ADDENDUM NUMBER 2 – JULY 22, 2024

AUGUSTA REGIONAL LANDFILL – LFGCCS EXPANSION

SOLID WASTE PERMIT NO. 21 AND NO. 585

Prospective Bidders are hereby advised of the following revisions to the Bid Documents for the subject Project:

SHEET TITLE
STORMWATER CULVERT 2

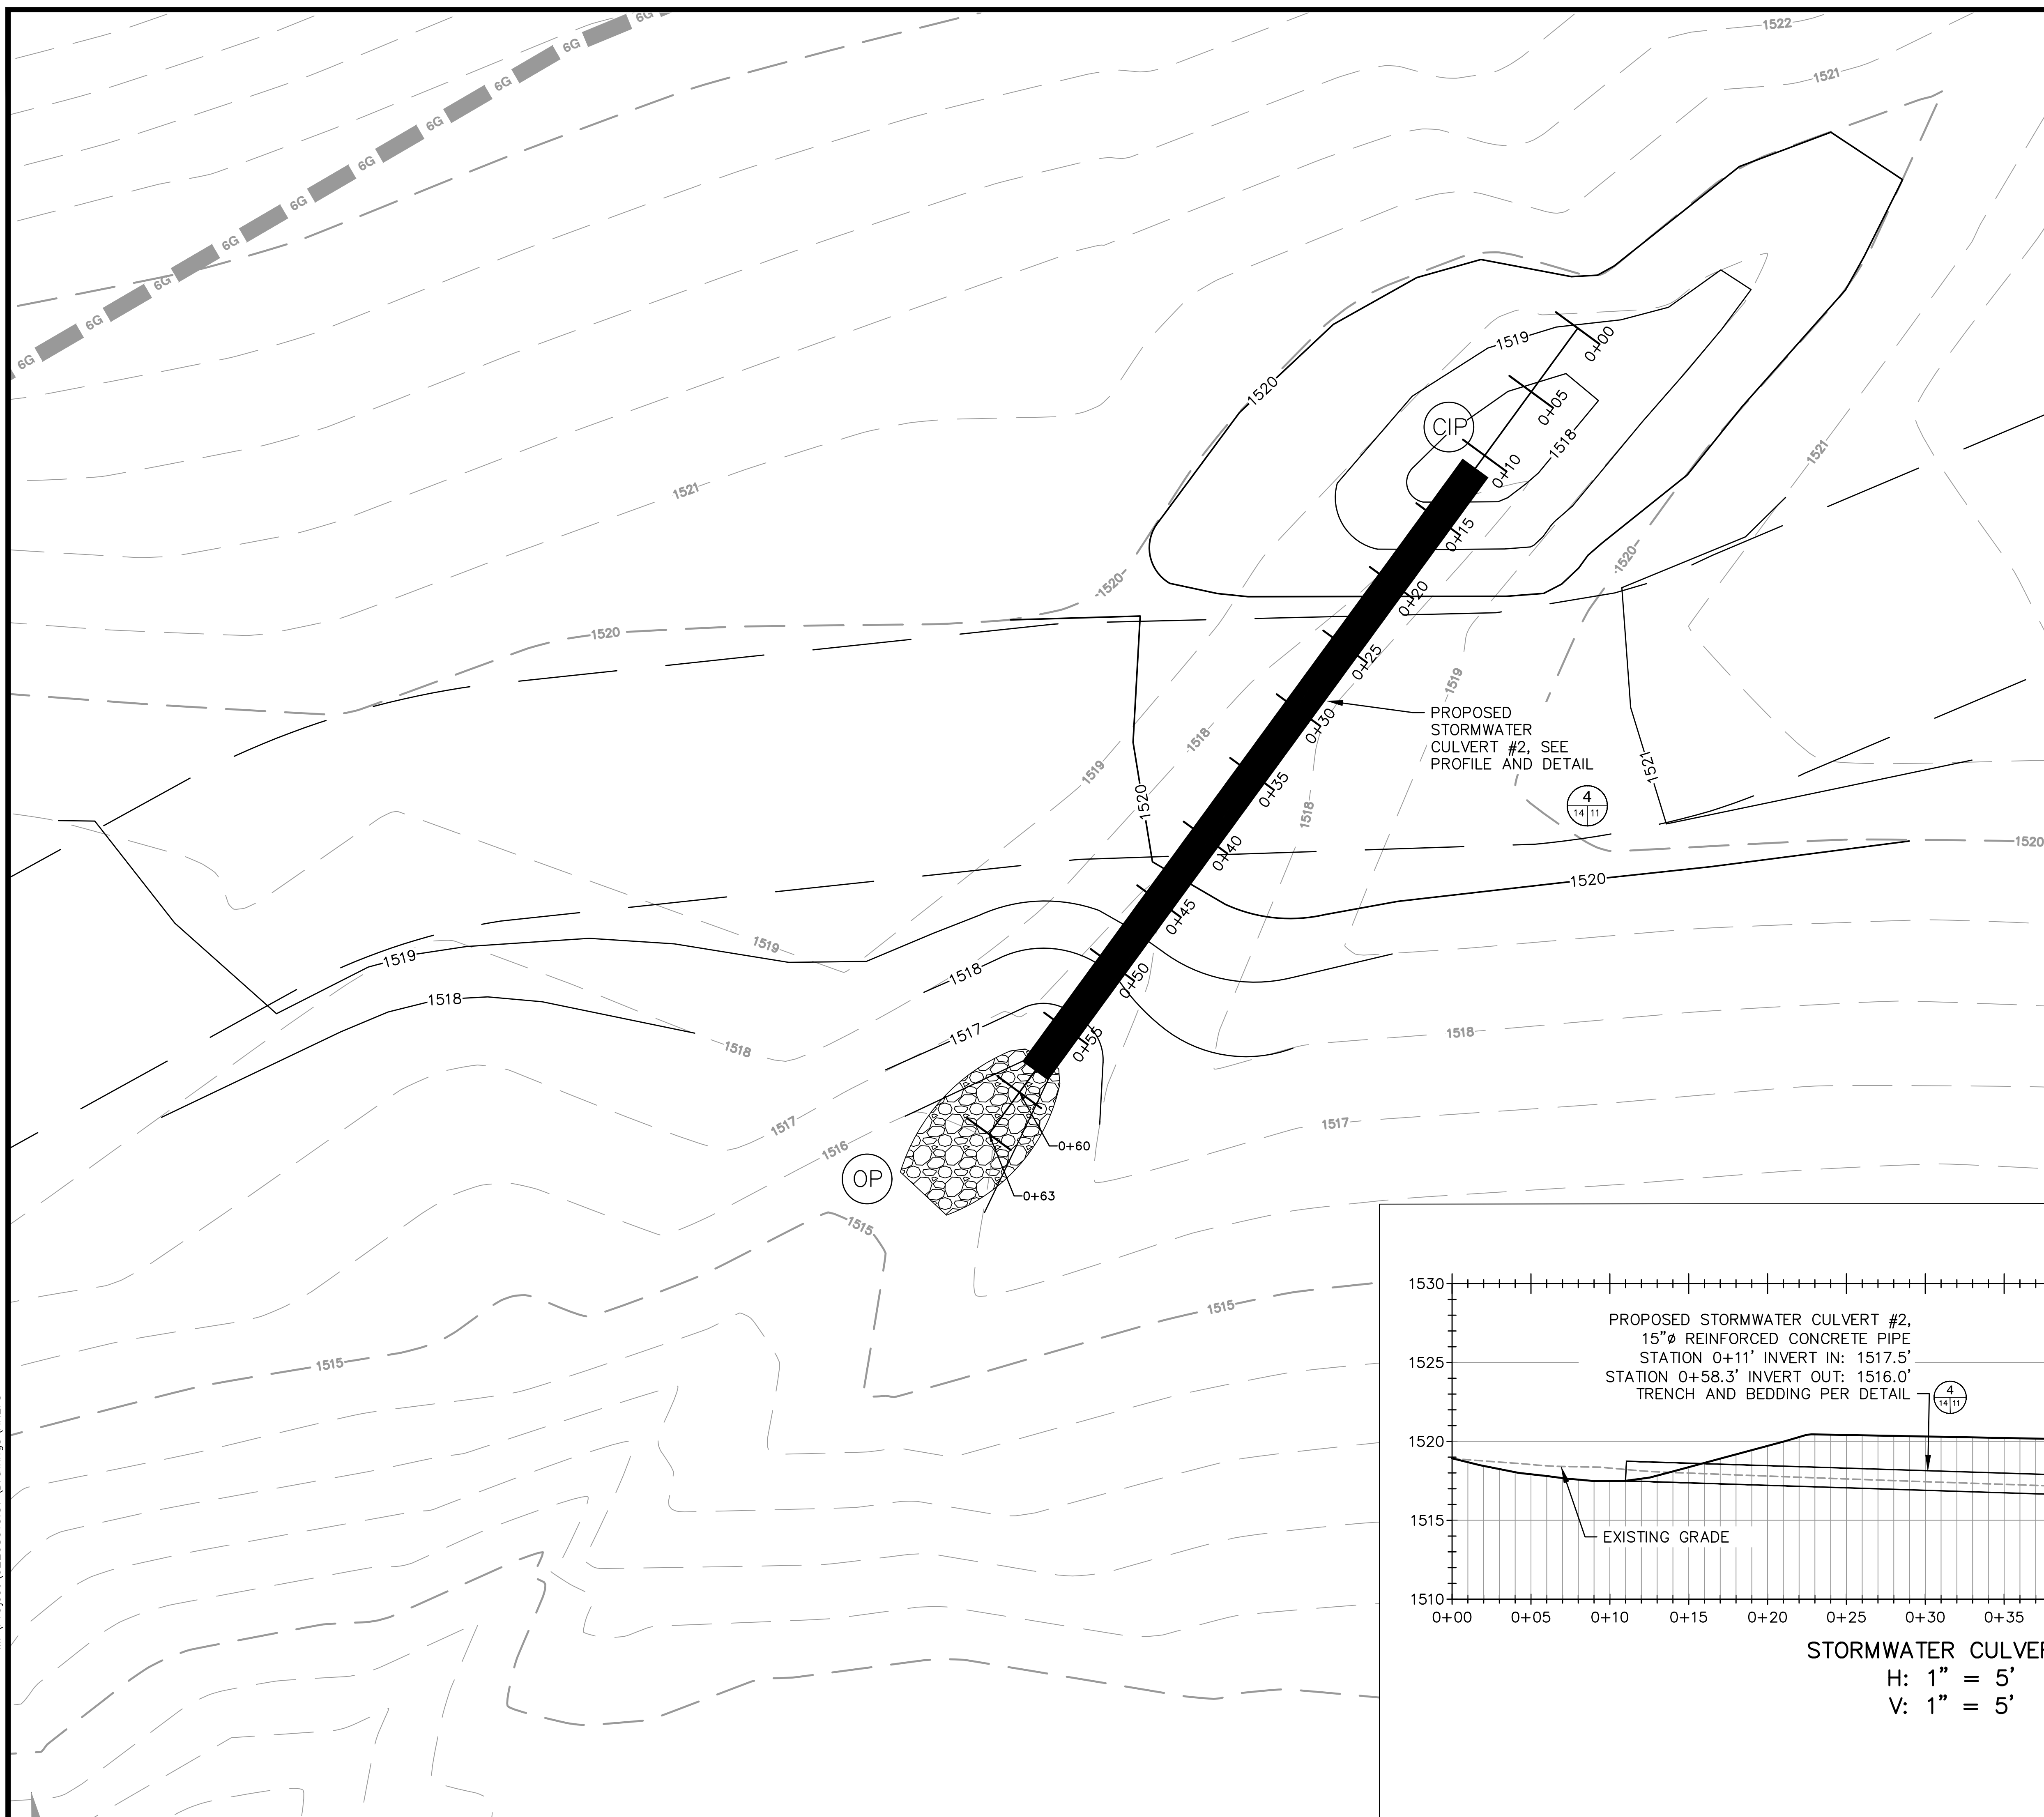
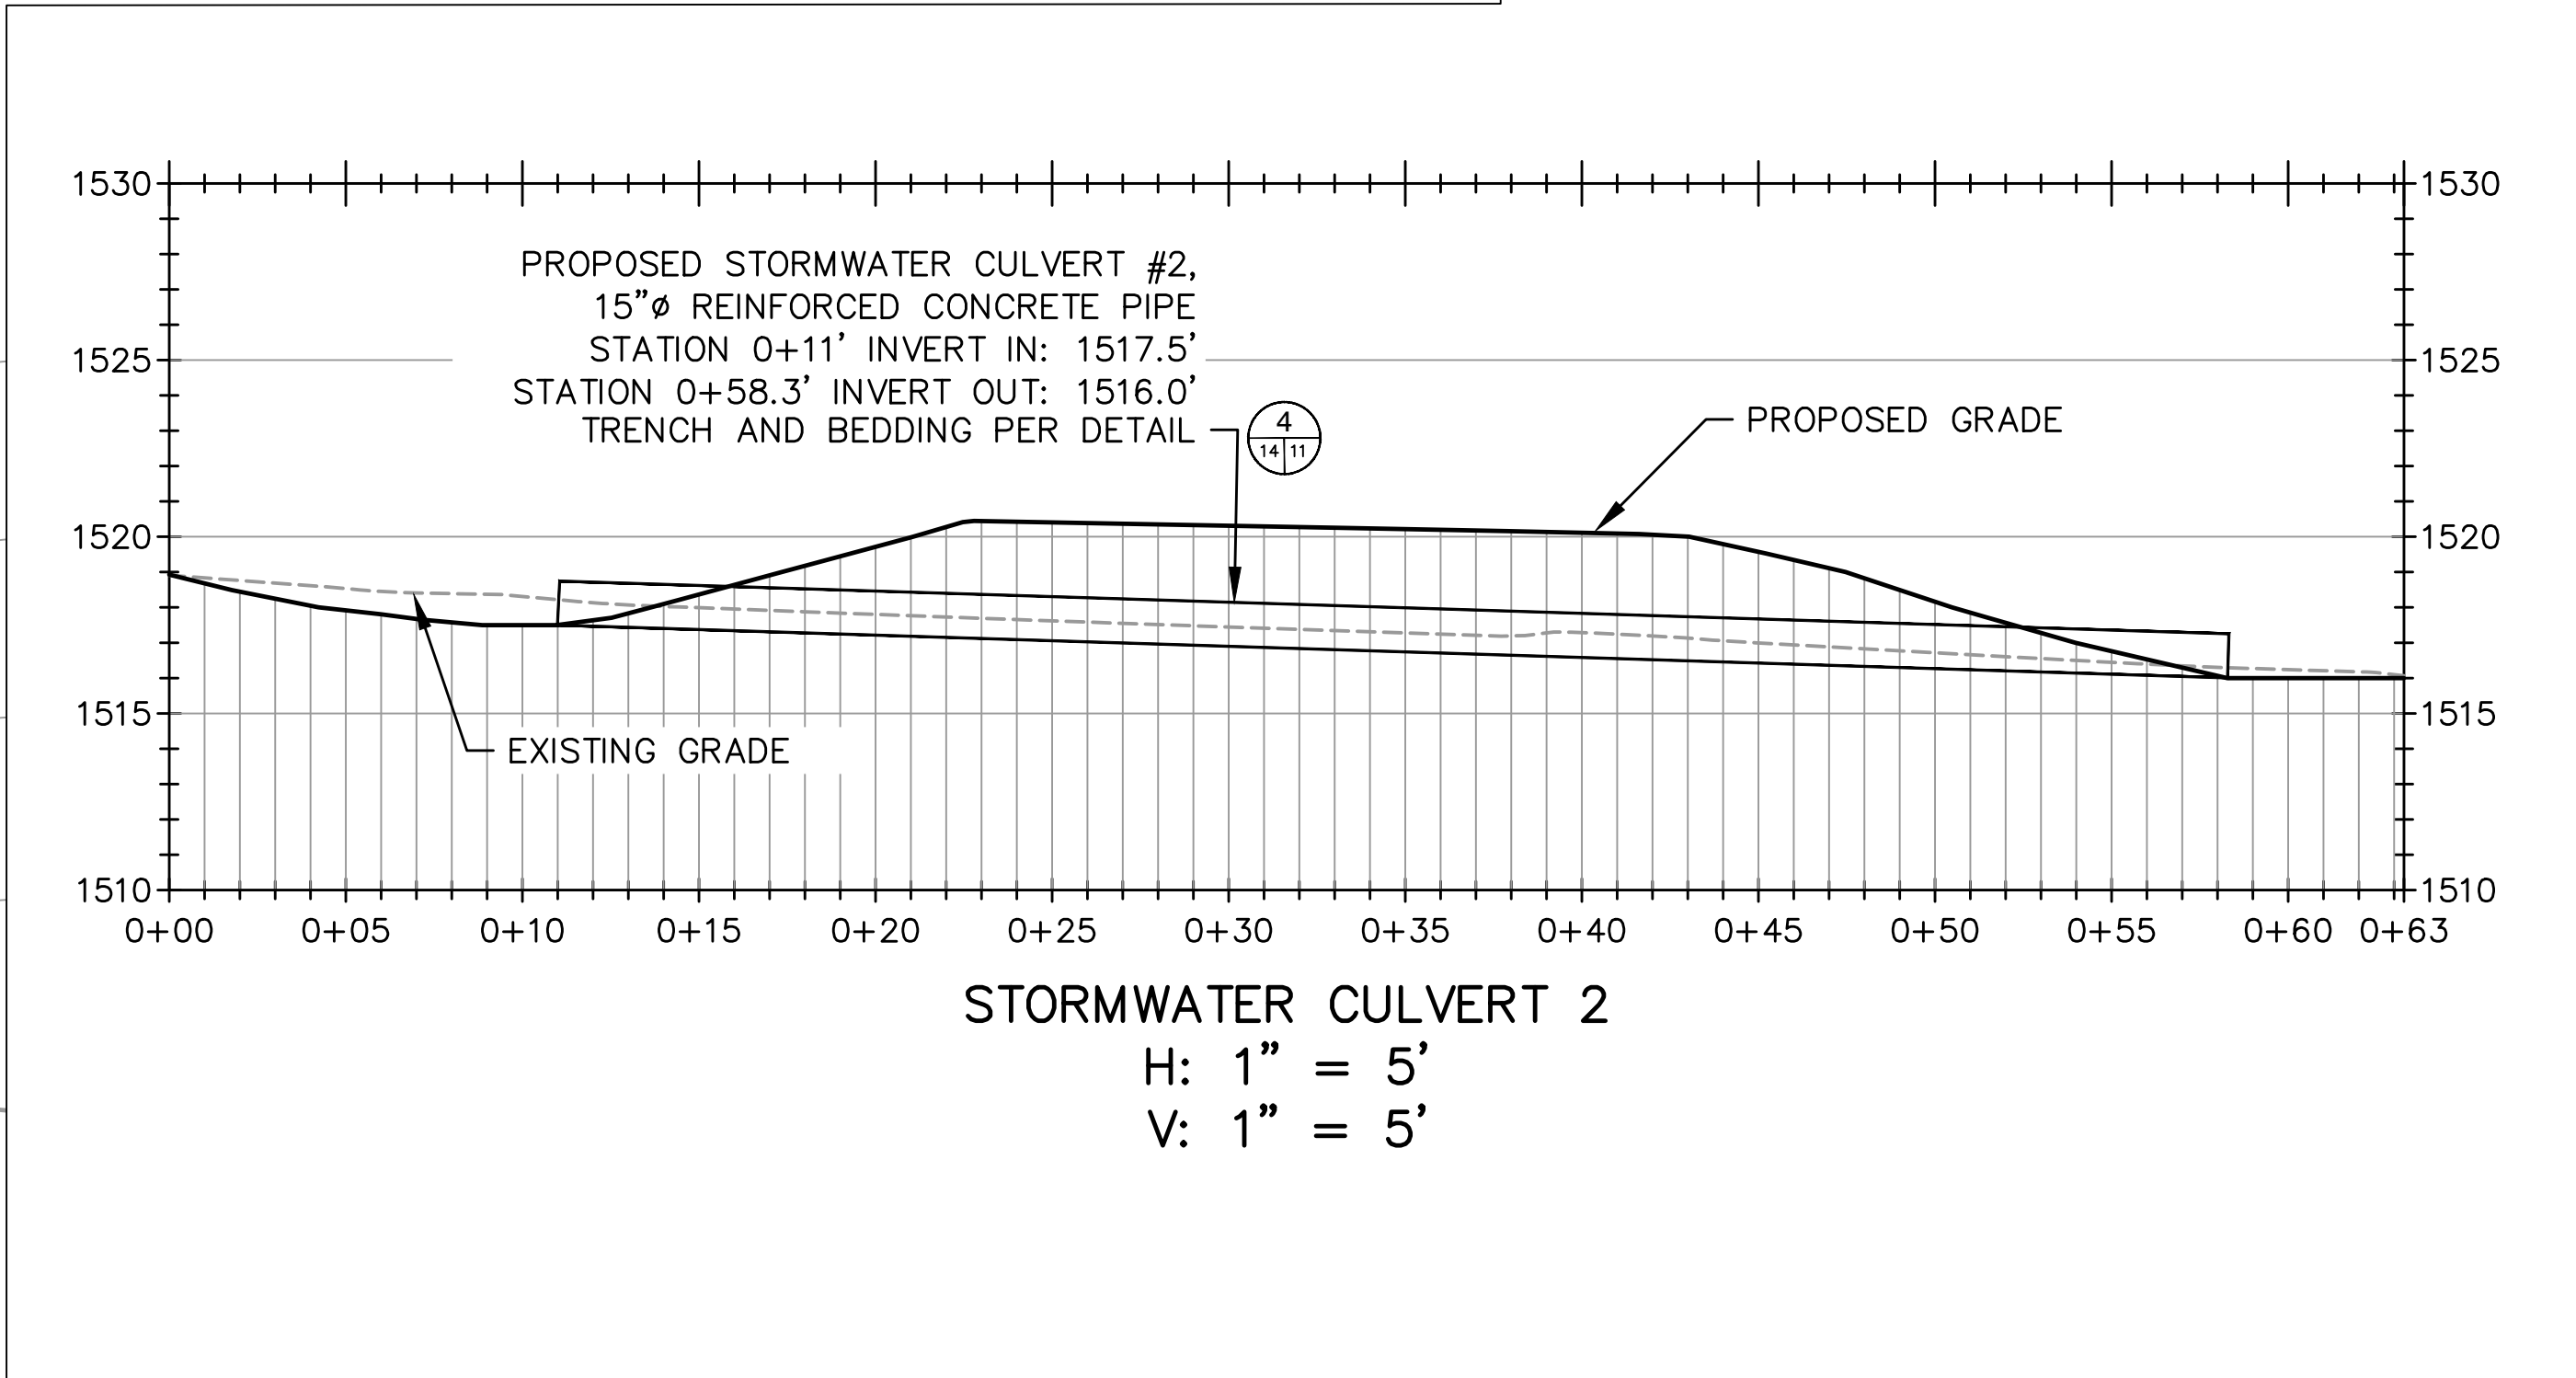
Question 9: Can profiles of the stormwater culverts be provided?

Answer: Profiles of the stormwater culverts have been added to new Sheet No. 13 and new Sheet No. 14.
